Product Change Notification

PCN26-48 - K12 Series – Packaging update for K12P

Design evolution:

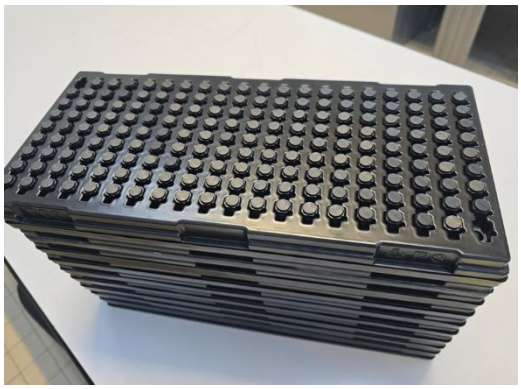
Packaging updated from bulk to tray.

Old in Bulk

New in Tray

Old packaging in Bulk:
250 pcs in plastic bag / small carton_ 150x95x95 mm
32 small cartons / Carton so **8000 pcs** / Carton 385x385x330 mm
Weight: 11 kg / carton

New Packaging in Tray:
178 pcs / trays _ 410*250*30 mm
10 trays / Carton so **1780 pcs** / Carton 410*250*200
Weight: 3.5 kg / carton
